## Service Info

### CNH\*\* - 228 0128 10 - 280/280 TGU6

**New design / Neues Design / Nouvelle conception / Nuevo diseño / Nuovo disegno**

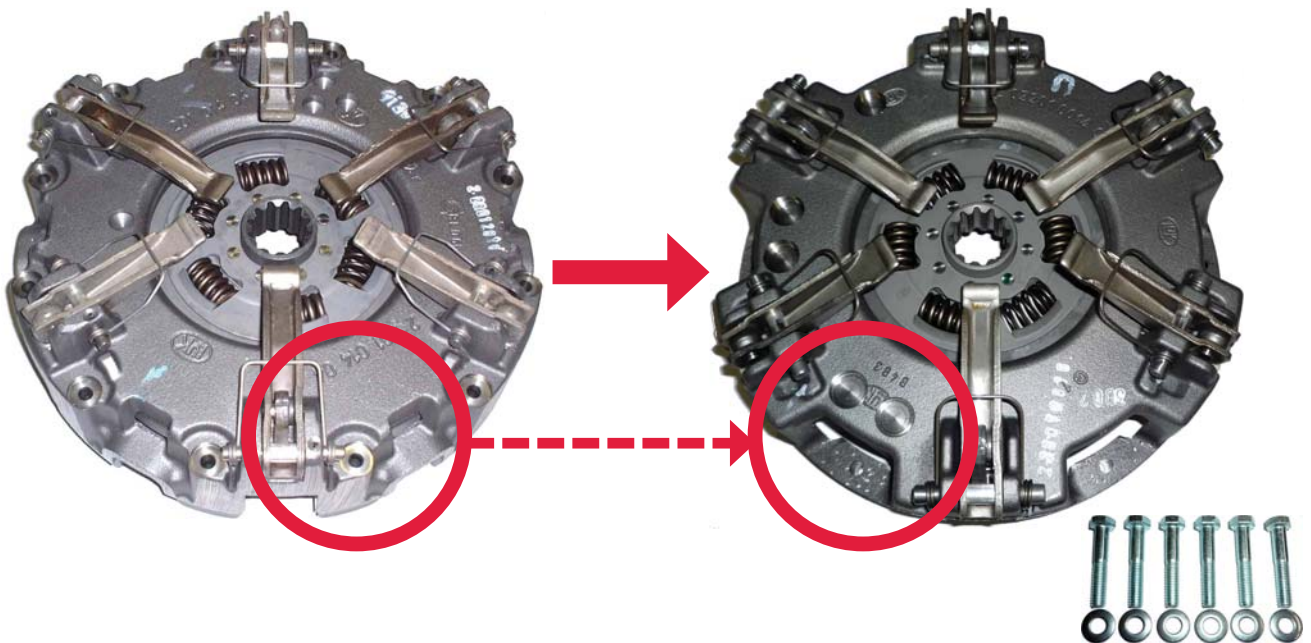
This new design utilises the latest clutch technology, using a vented housing for improved cooling and heat dispersal.

**Fully interchangeable with existing clutches with no modifications required to vehicle or flywheel.  
New fixation bolt set 6 x M8 x 1.25 x 50mm is supplied with new designs to accommodate the lower housing.**
